**Subject:** Response to U.S. EPR Design Certification Application RAI No. 555 (6611), FSAR Ch. 7, Supplement 1

**Question 07.01-54:****Open Item****Follow up to RAI 505, Question 07.01-46**

**Question 07.01-55:****Open Item****Follow up to RAI 505, Question 07.01-46**

Figure 7.1-8—Priority and Actuator Control System Architecture

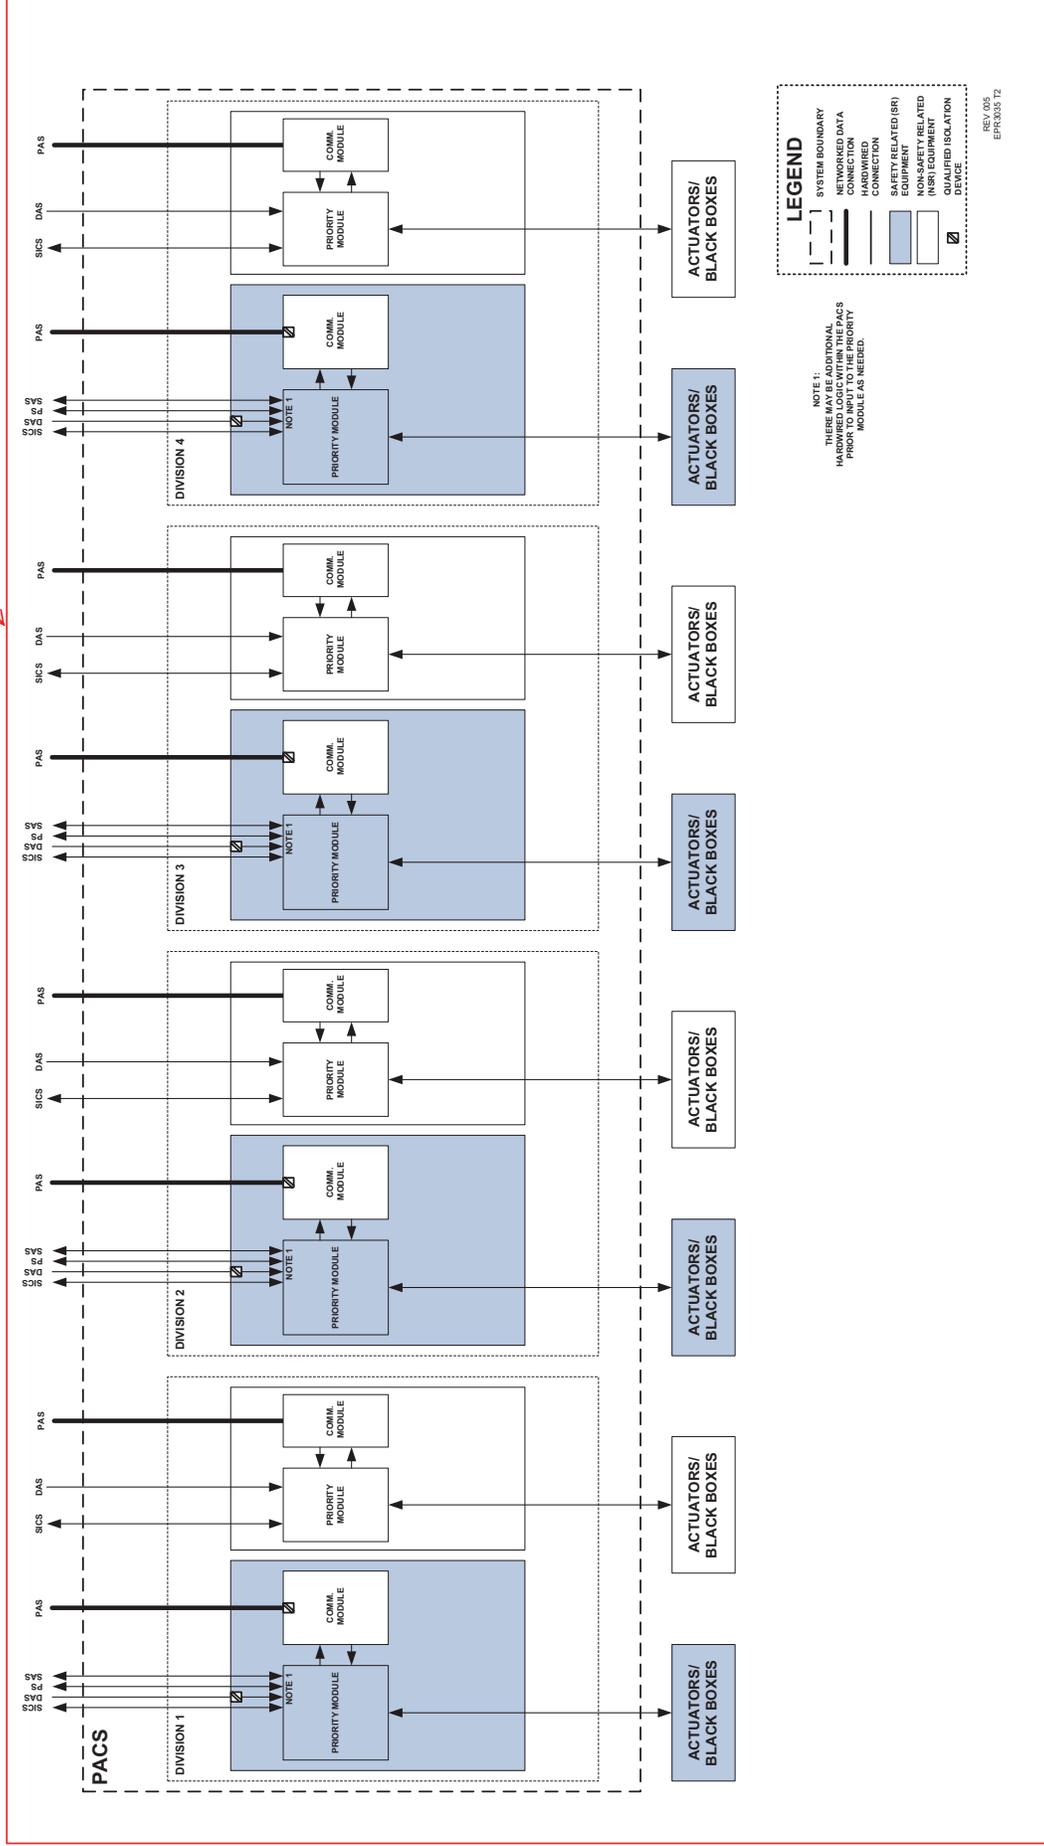
U.S. EPR FSAR Tier 2, Figures 7.1-2, 7.1-6, and 7.1-8, will be revised to show a bi-directional hardwire signal between the PS and PACS.

Figure 7.1-21—PACS Priority Module Logic Diagram  
Sheet 1 of 2

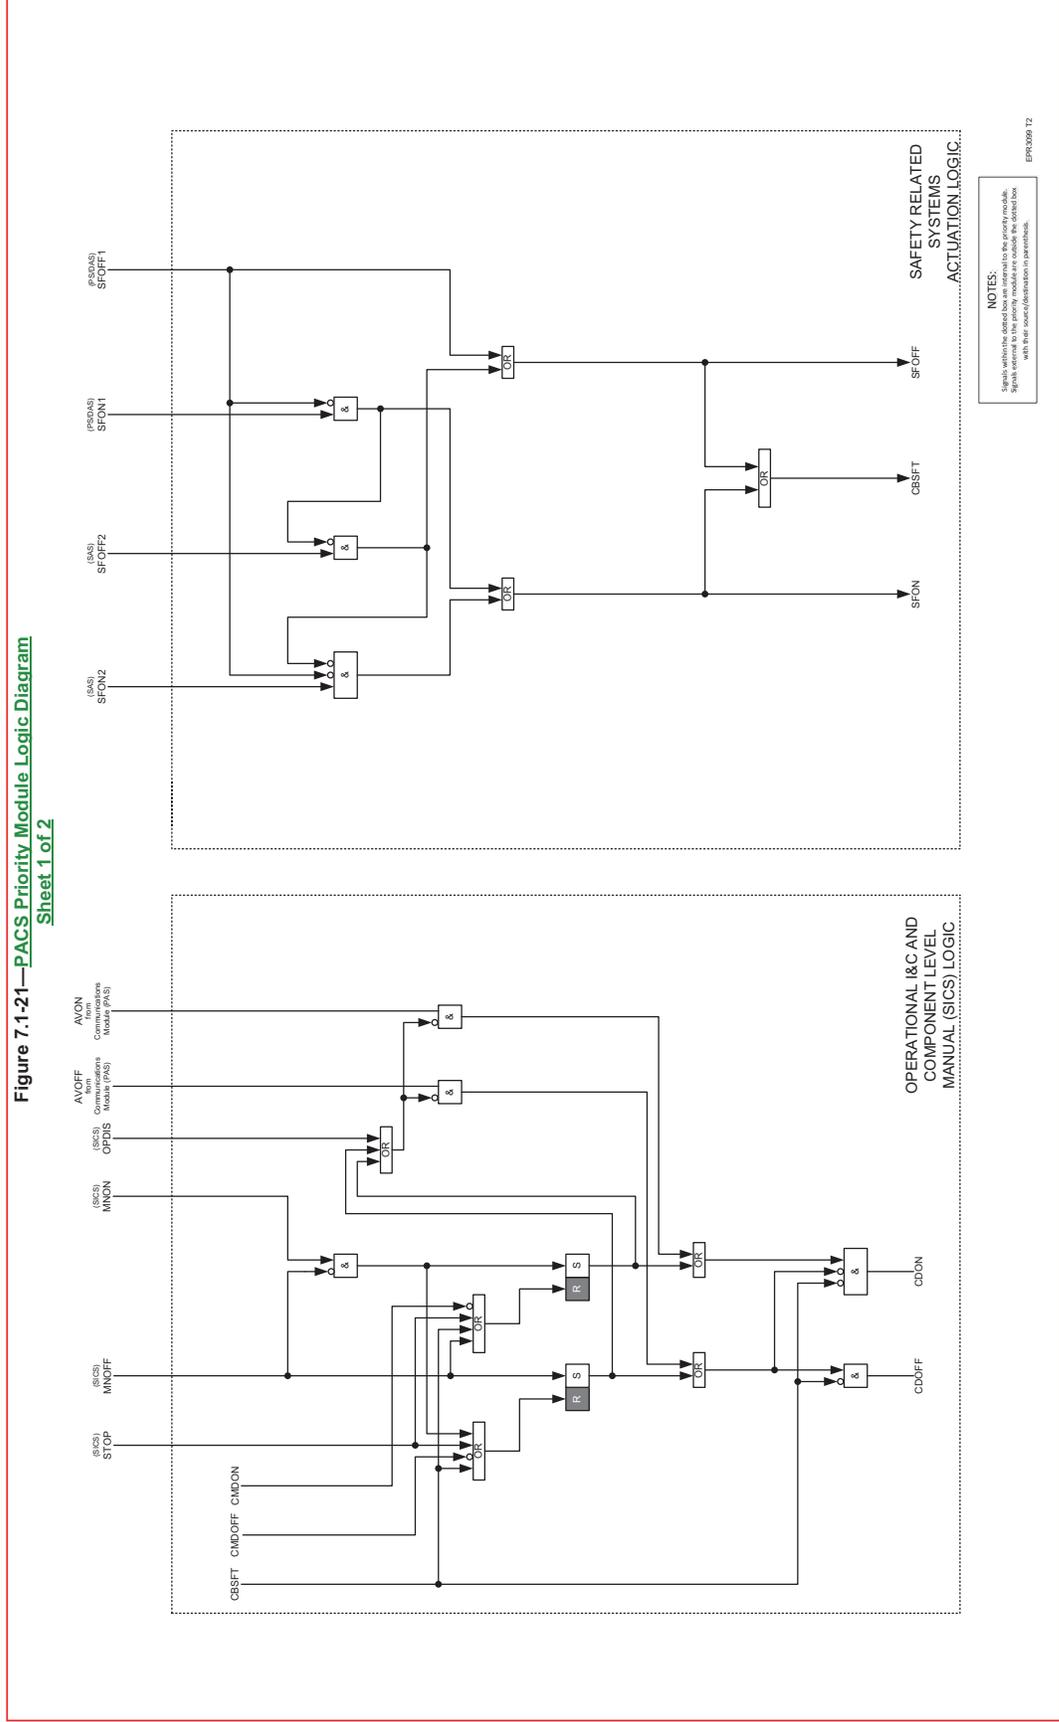
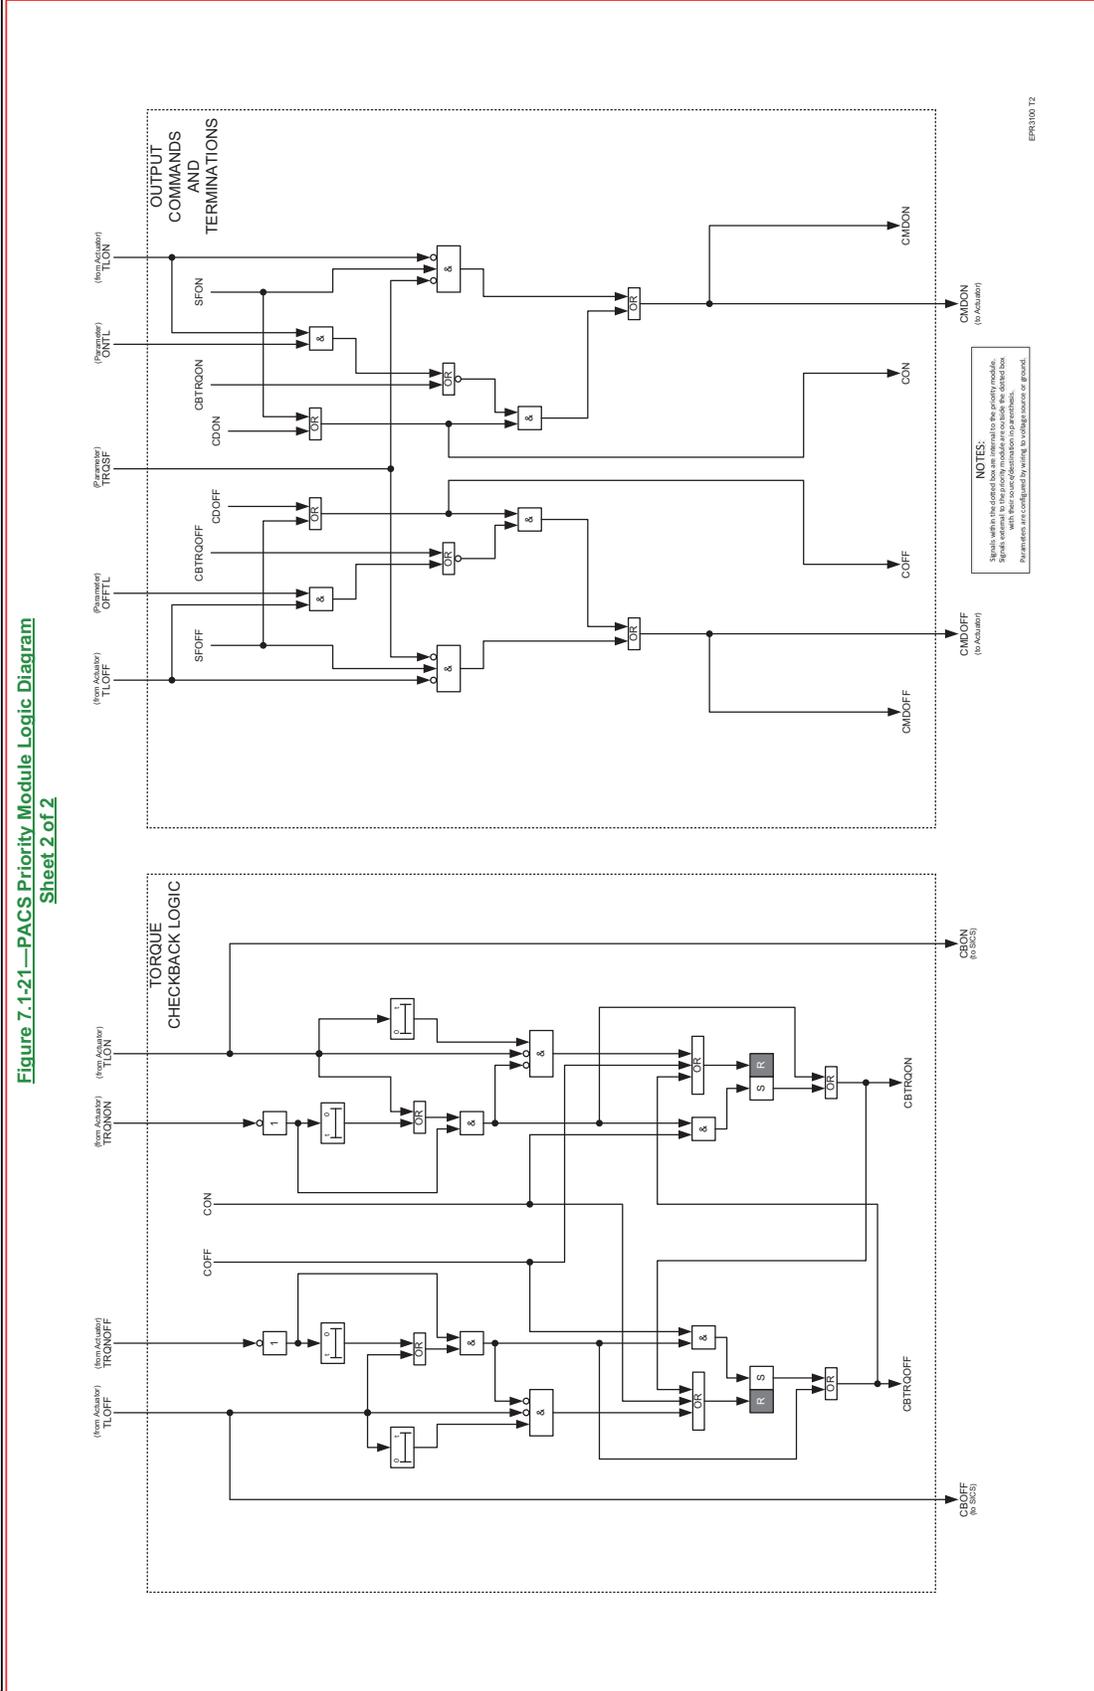
4. These definitions for latched and unlatched should not be applied generically to all interfacing I&C systems. The priority module logic diagram (U.S. EPR FSAR Tier 2, Figure 7.1-21 (Sheets 1 and 2)), shows which inputs are latched (through the use of the Memory logic block), nonlatched (no use of the Memory logic block), and delayed (through the use of Time Delay logic blocks). The priority module logic diagram (Figure 7.1-21 (Sheets 1 and 2)) shows how a signal may be unlatched in the PACS.
5. The EFWS actuation function is latched and unlatched both automatically and manually. The pulse duration is used to initiate the EFWS actuation on SIS and LOOP from the PS; then the signal is removed so the SAS EFWS SG level control function can have priority and control the EFWS level control valve.

The priority module logic diagram (U.S. EPR FSAR Tier 2, Figure 7.1-21 (Sheets 1 and 2)), shows how latched inputs (through the use of the Memory logic block), nonlatched inputs (no use of the Memory logic block), and delayed inputs (through the use of Time Delay logic blocks) are used to provide logic for prioritization.

3. Blocking of the PAS commands is done by the PACS module. Once the OPDIS switches provide 2-out-of-4 vote signal, this is sent to the priority module of the PACS. The priority module of the PACS, upon receiving the OPDIS signal, blocks the actuation inputs from the communication module. This prevents the PAS from actuating a safety-related component. See the logic diagram for the PACS priority module (U.S. EPR FSAR Tier 2, Figure 7.1-21 (Sheets 1 and 2)) to see the OPDIS input interface.

Figure 7.1-30—Operational I&C Disable Switch Configuration

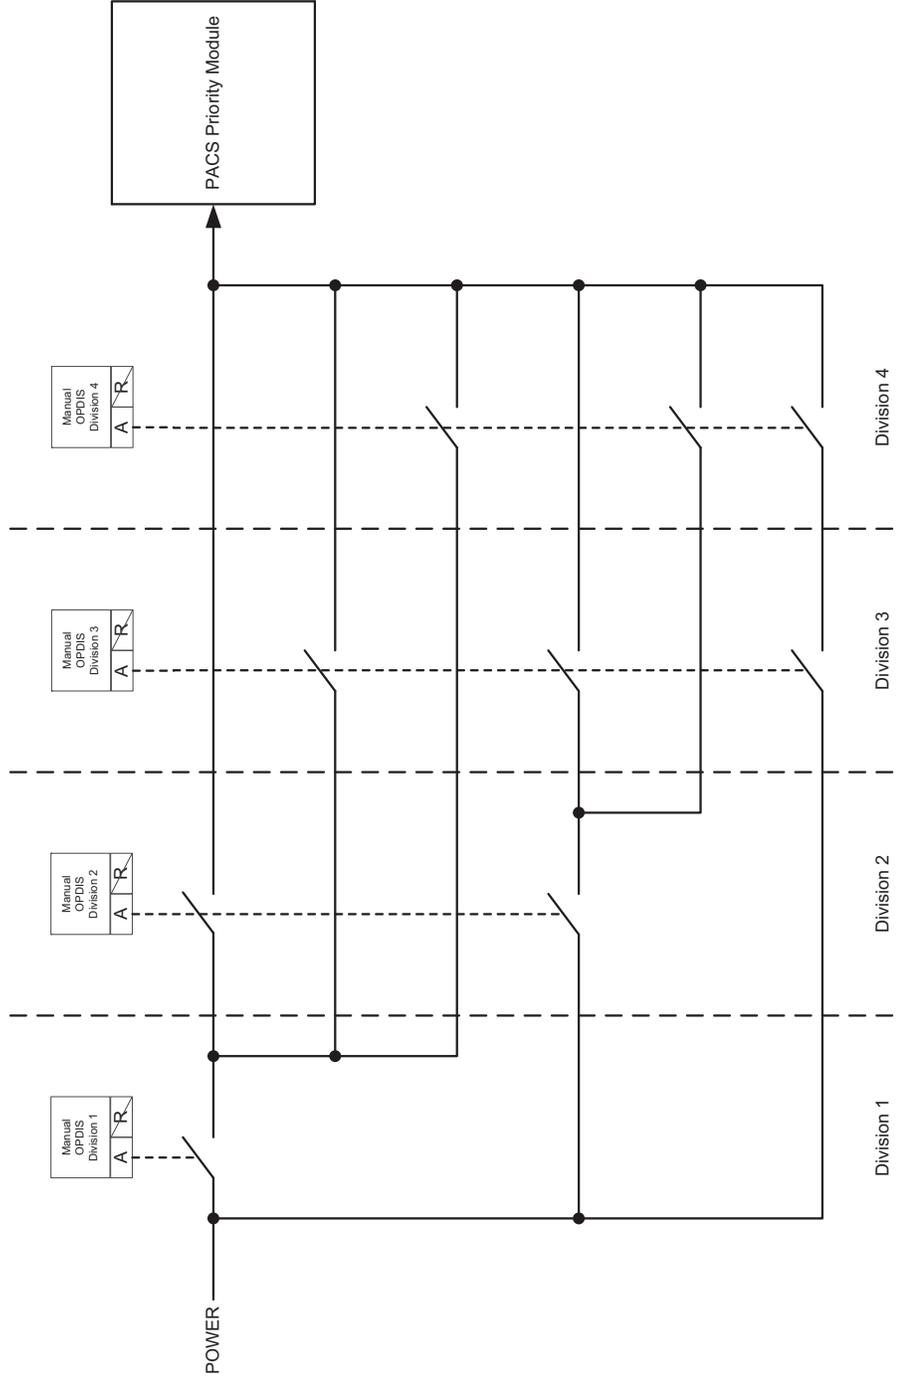
- d-4. In terms of the 2oo4 voting logic in the OICS: (i) Does this take place within the PS? (ii) Is this hardwired logic? (iii) Does the applicant have a figure that demonstrates this voting configuration for the staff’s review?
